PLANNING COMMISSION AGENDA

December 16, 2010

29. SDR-40146 - SITE DEVELOPMENT PLAN REVIEW - PUBLIC HEARING - APPLICANT: THE SMITH CENTER - OWNER: CITY OF LAS VEGAS - Request for a Major Amendment to a previously approved Site Development Plan Review (SDR-26709) FOR A PROPOSED FIVE-LEVEL, 335-SPACE PARKING GARAGE WITH WAIVERS OF THE SYMPHONY PARK PARKING STRUCTURE DESIGN STANDARDS, BUILD-TO LINE STANDARD, REQUIRED RETAIL FRONTAGE STANDARD AND STREETSCAPE STANDARDS on a portion of 5.10 acres at the northeast corner of Clark Avenue and Promenade Place (APN 139-33-610-026), PD (Planned Development) Zone, Ward 5 (Barlow). Staff recommends DENIAL.

SHEET NO.
GA2.01

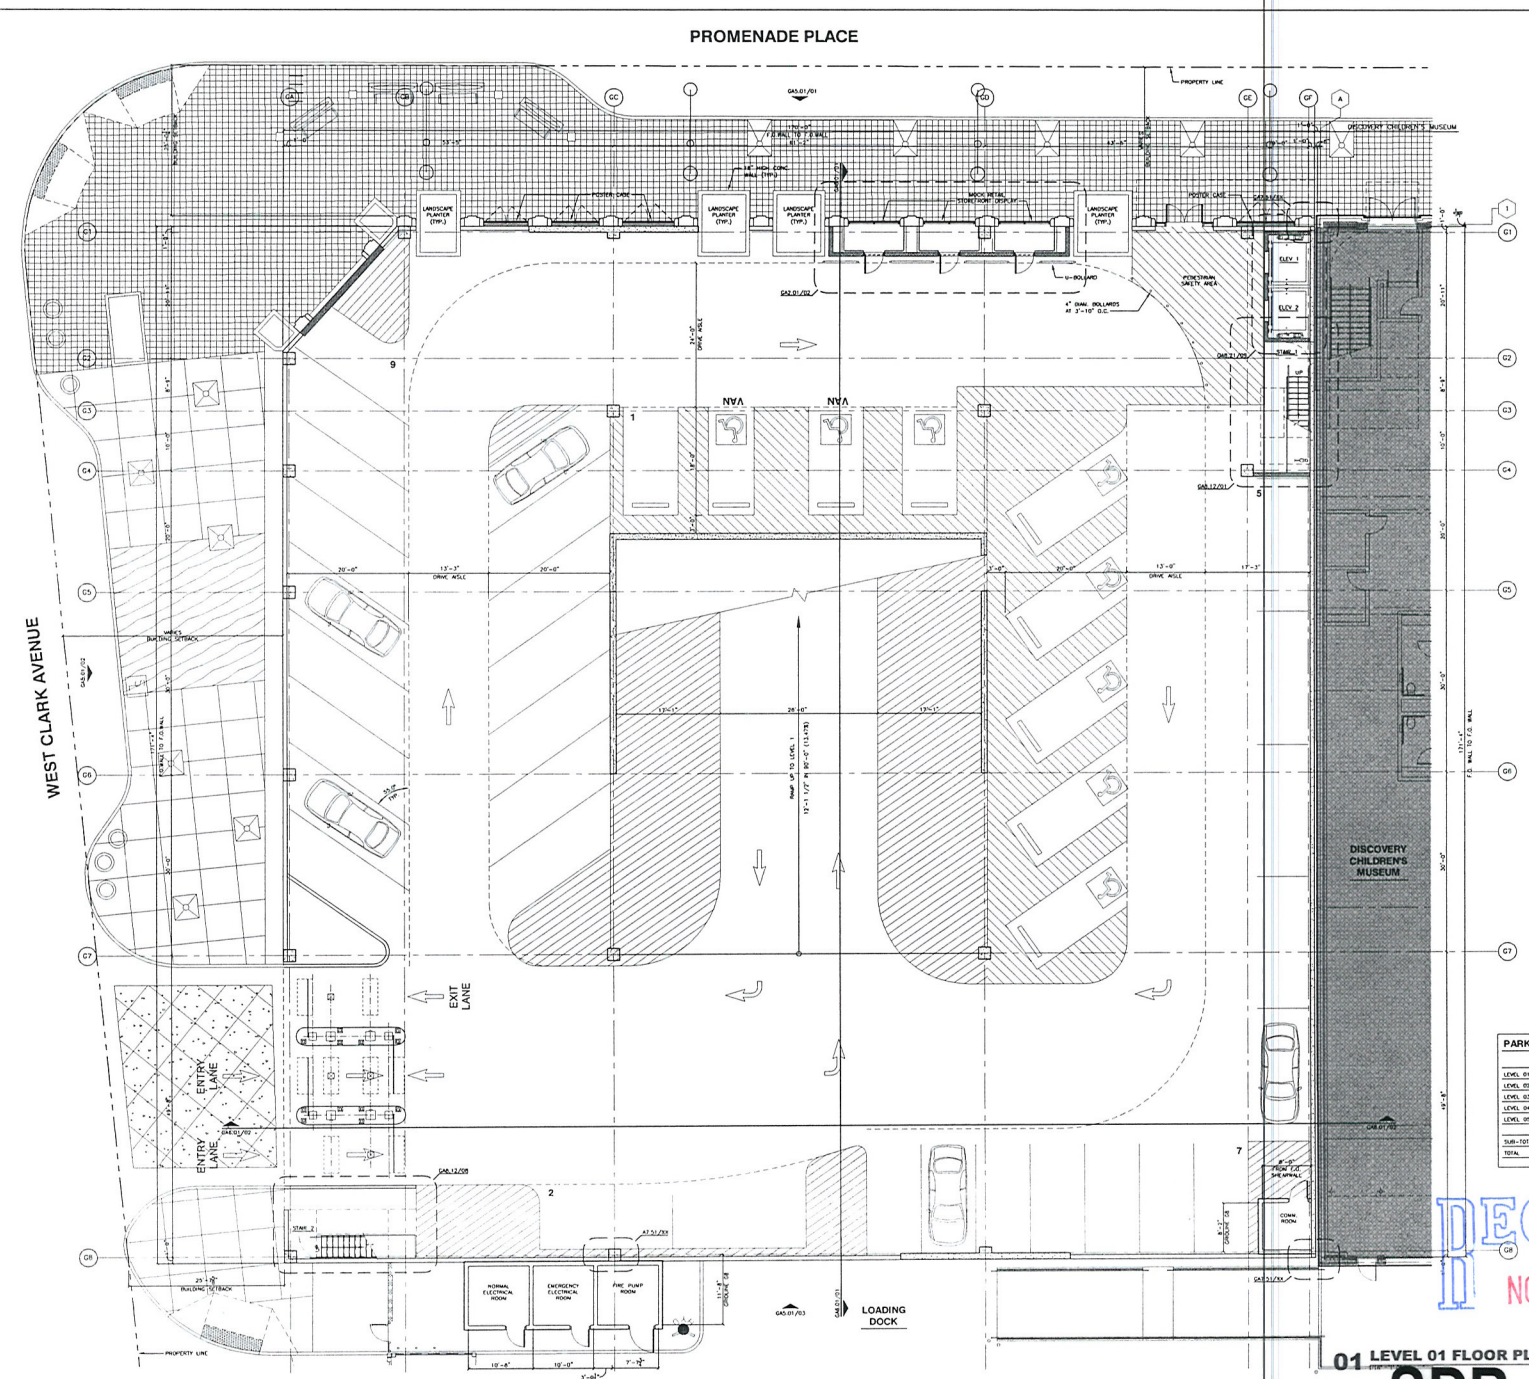
1. Sheet GA2.01- the circulation of the ground level shown in the revised garage is confusing and creates conflict points for patrons. Please modify. Also the planters shown on the Promenade Place sidewalk extend too far into the sidewalk and reduce the pedestrian space well below the 10 foot minimum required. Please reduce the size of the planters to the build-to-line.
